Table of Contents – Chapter II

This section of the Responses to Comments addresses comments related to the new NPDES permit’s regulation of Merrimack Station’s discharges of waste heat (also referred to as “thermal discharges”) to the Hooksett Pool section of the Merrimack River. In prior documents, Region 1 has discussed in detail the source and character of the Facility’s thermal discharges, as well as the legal requirements governing regulation of such discharges. *See, e.g.*, AR 608 (the Fact Sheet for Merrimack Station Draft Permit (“the 2011 Fact Sheet”) (Sept. 29, 2011), pp. 4-11; AR 618 (Attachment D to the 2011 Fact Sheet: Clean Water Act NPDES Permitting Determinations for the Thermal Discharge and Cooling Water Intake Structures at Merrimack Station in Bow, New Hampshire (“the 2011 Determinations Document”) (Sept. 29, 2011); AR 1533 (Joint Public Notice for the Reopening of the Public Comment Period for the Draft NPDES Permit for Merrimack Station ...) (“the 2017 Public Notice”) (August 2, 2017); AR 1534 (Statement of Substantial New Questions for Public Comment (Discussion of Substantial New Questions and Possible New Conditions for the Merrimack Station Draft NPDES Pe

Figure - Overlay of Power Plants and Findings of *Corbicula fluminea*²⁸³

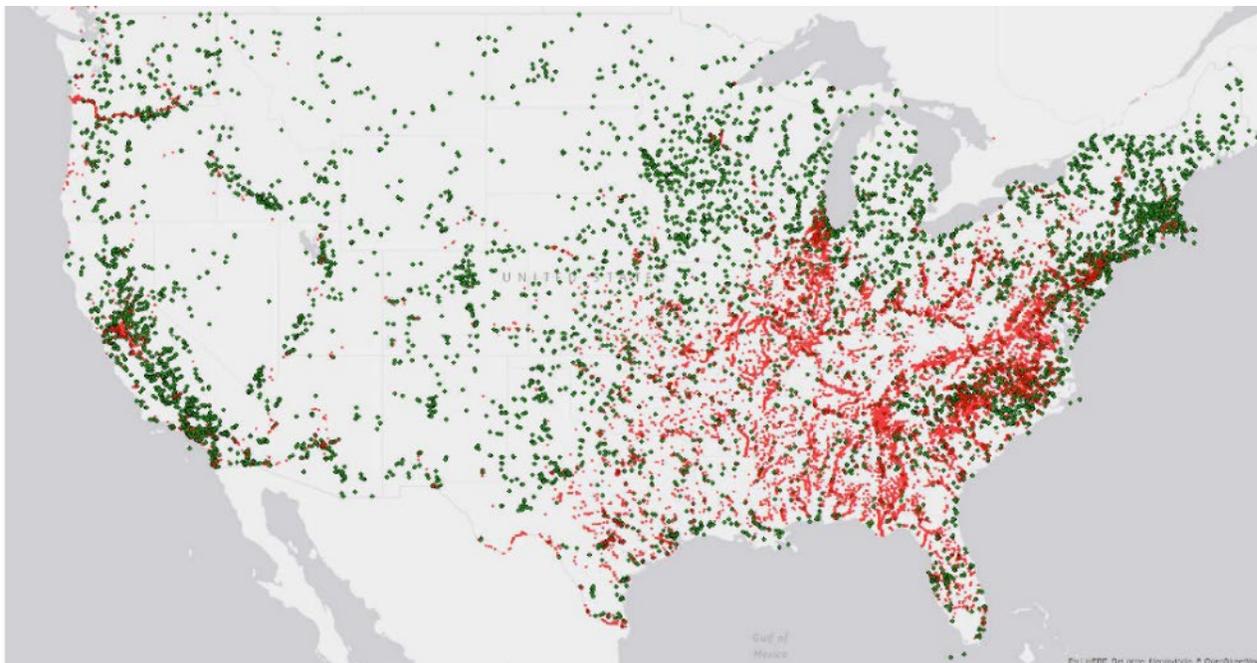
The red dots shown on the map represent Asian clam locations reported in the United States Geological Survey (USGS) database.²⁸² Further, the Asian clam is extensively found near power plants (shown in green):

Given EPA's silence concerning the Asian clam despite receiving the findings of Normandeau that Hooksett Pool hosts a healthy, BIP of fish and macroinvertebrates, PSNH did not anticipate EPA's interest in the Asian clam until learning of it by happenstance approximately three years ago. In 2014, PSNH observed EPA conducting dives, unannounced, with NHDES in the immediate vicinity of Merrimack Station. Near this same time period, EPA responded to several Freedom of Information Act ("FOIA") requests issued by PSNH concerning the Merrimack Station permit proceeding.²⁸⁴ Although EPA never mentioned its interest in the Asian clam to PSNH, its permit holder, documents contained within EPA's FOIA production made clear EPA had fixed its focus on the Asian clam, almost to the exclusion of other species. As a mounting number of documents from EPA's FOIA production focused on the Asian clam, PSNH grew concerned EPA might be considering a new basis to attempt to shore up the fatally flawed Draft Permit and its denial of PSNH's § 316(a) variance request that were based on EPA's erroneous determination that the polluted Merrimack River of the 1960s hosted a BIP and was the appropriate baseline for comparison.²⁸⁵ Indeed, documents included in one of EPA's FOIA productions revealed that, in September 2015, EPA had contemplated a dive study for the purpose of assessing the Asian clam's effect on the Hooksett Pool BIP.²⁸⁶ As explained in this "Project Plan" document, EPA sought to improve its "understanding of the power plant's influence on this invasive species" and, in turn, to "evaluate the plant's ability to meet state and federal water quality standards, and its NPDES permit requirements, as they apply to protecting the resident biological communities."²⁸⁷ Among its study objectives, EPA planned to "assess the abundance of *Corbicula* relative to native epifaunal and infaunal macroinvertebrates," in addition to "*Corbicula*'s capacity to displace native invertebrates, including mussels."²⁸⁸ However, EPA's study plan was abandoned and the evaluation was never undertaken.²⁸⁹
